Consent documentation quality for new housing

Ian Page

BRANZ Study Report SR355

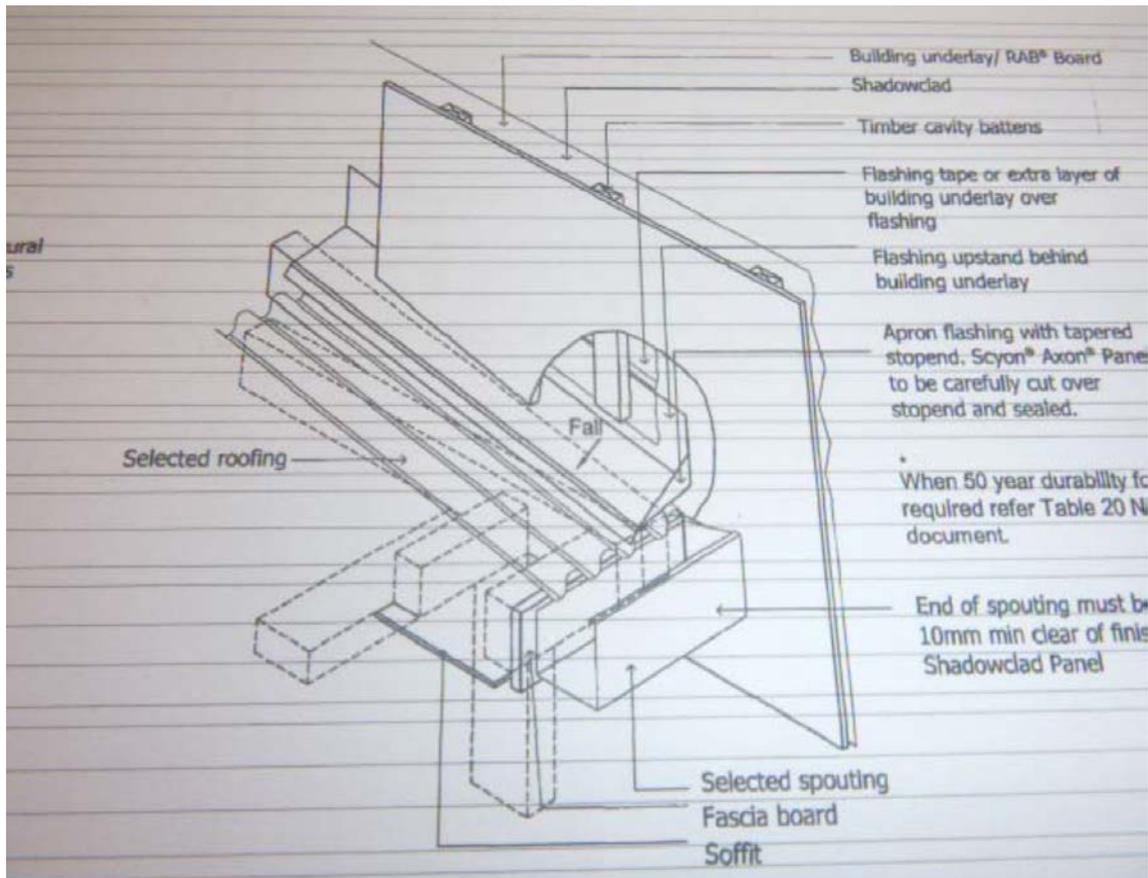
Details are referenced but are missing or are not applicable.

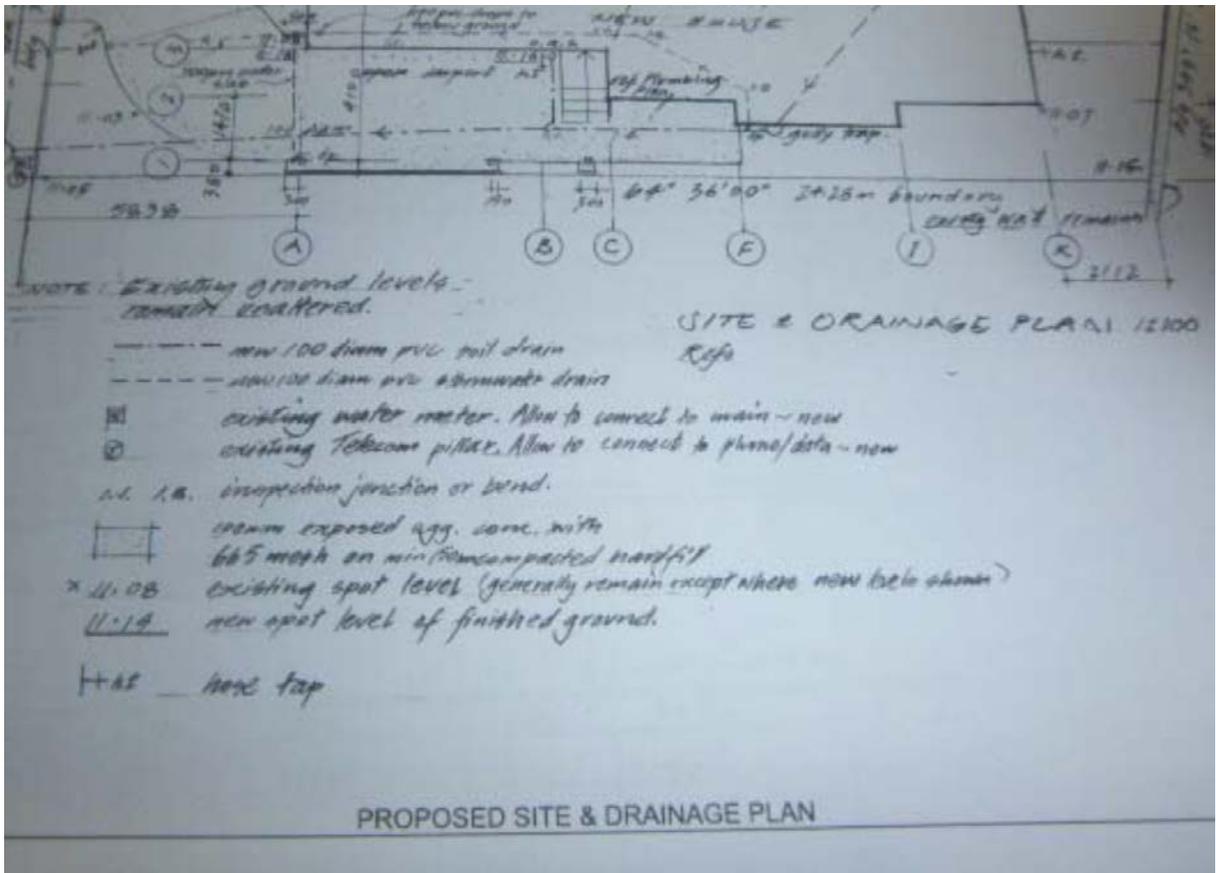
Not all of these references are helpful to the builder: What part of the geotechnical report does the builder need to read? What manufacturer's product literature applies?

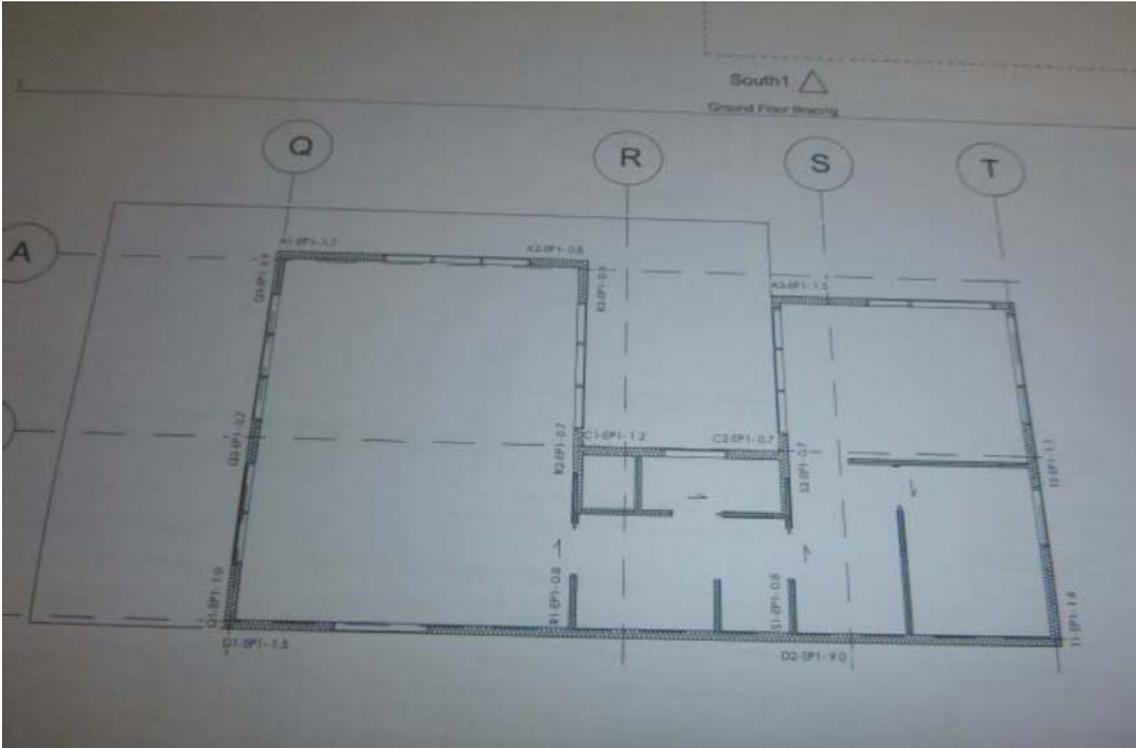
Handwritten notes can be difficult to read.

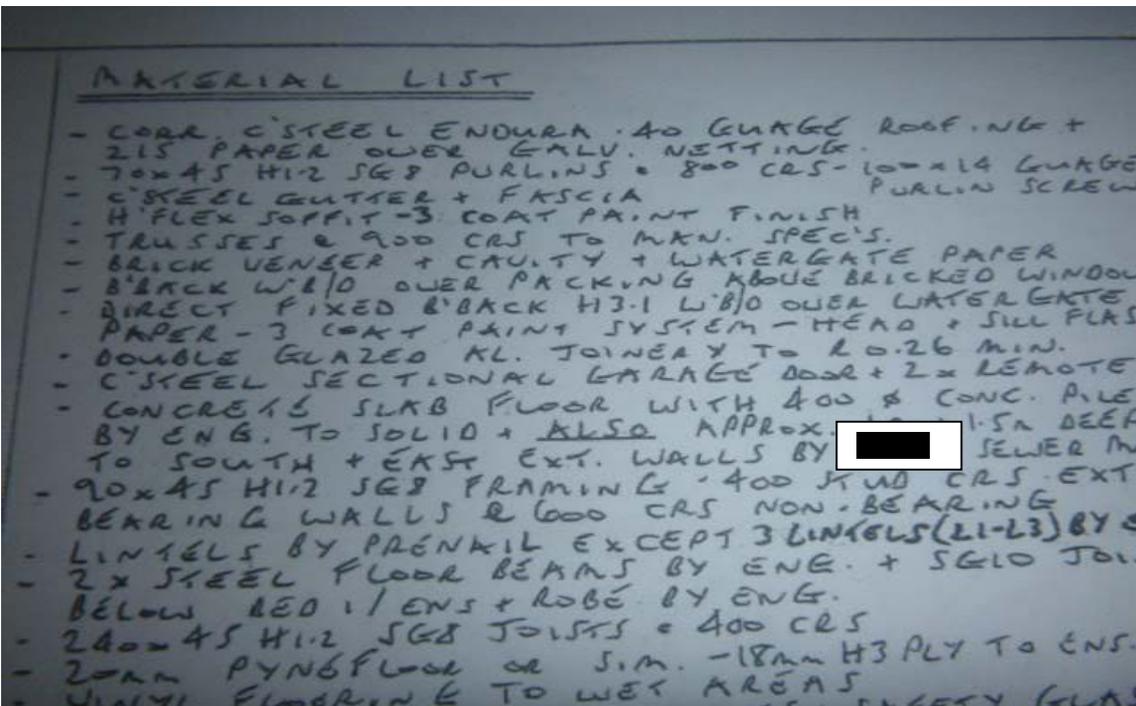
Bracing plan has no key to the bracing type.

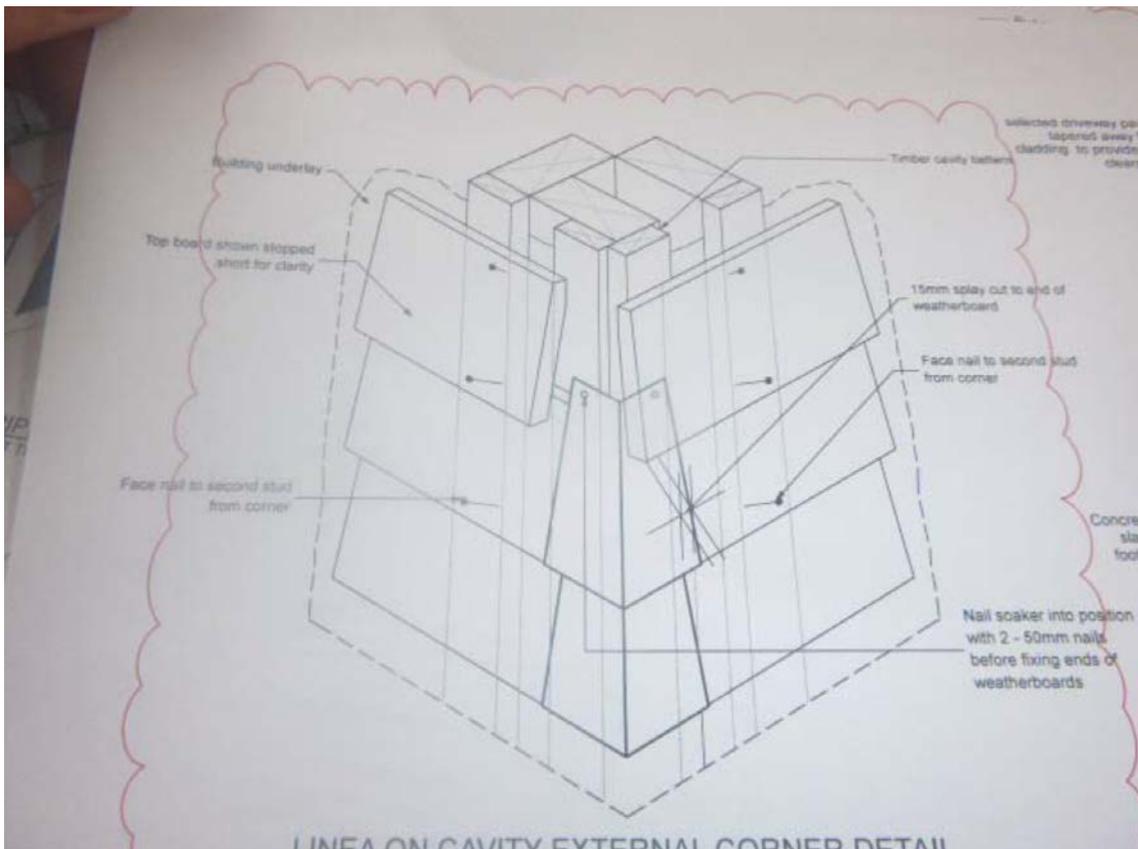
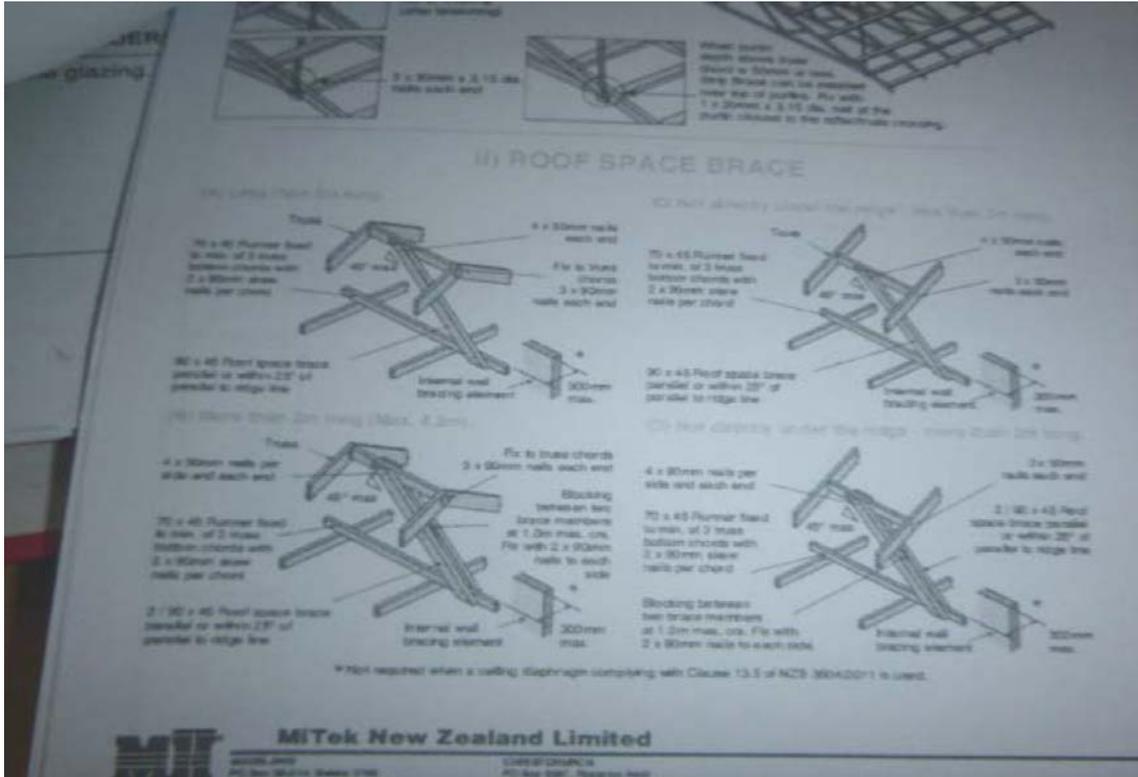
A materials list is good to have but can be difficult to read.

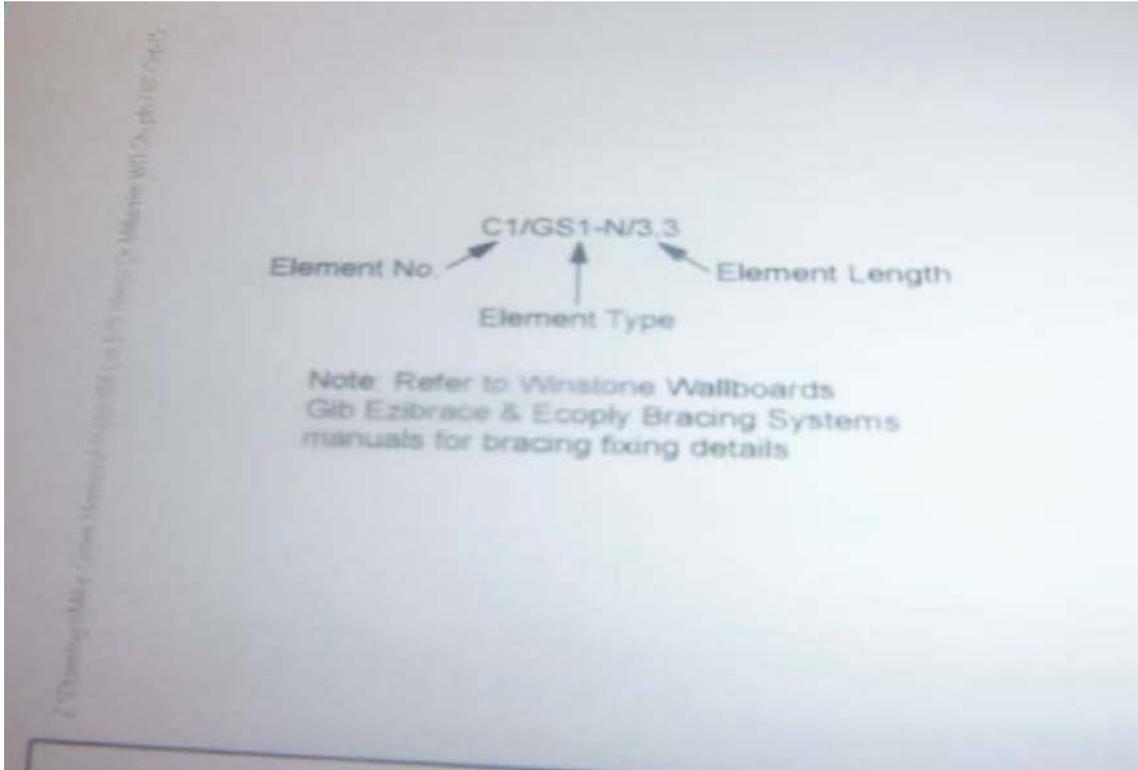
Typical examples of use of manufacturers' details – not all details are relevant for this house.

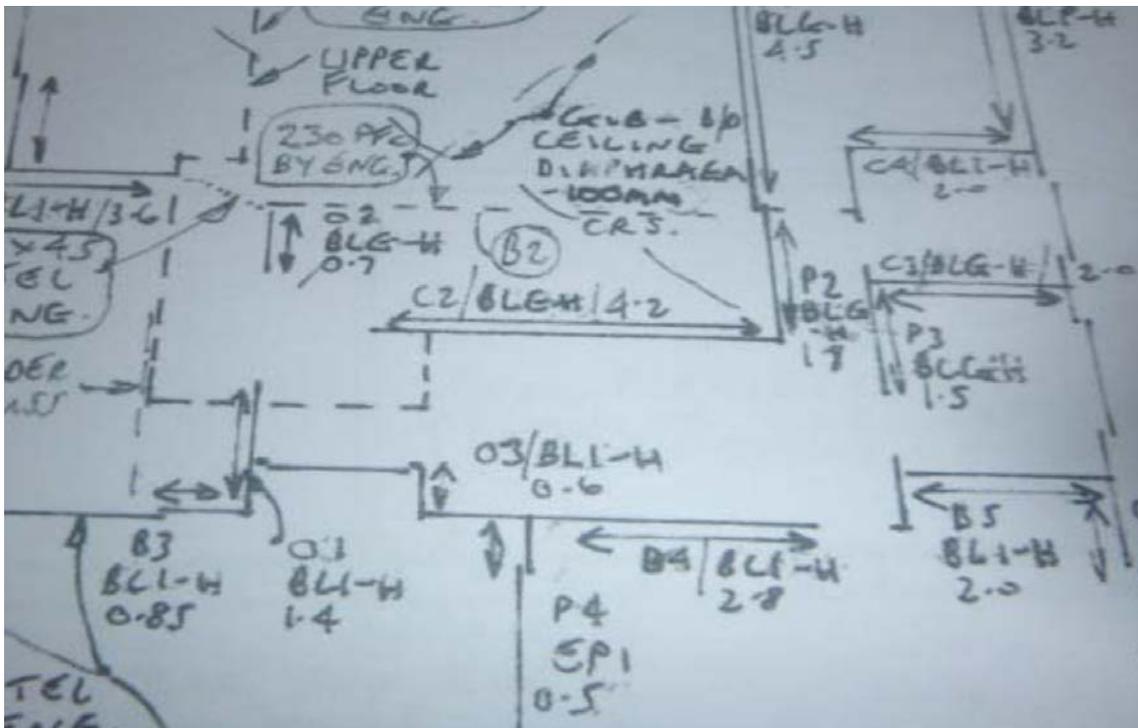
Typical example of reference to manufacturer's literature for construction details.
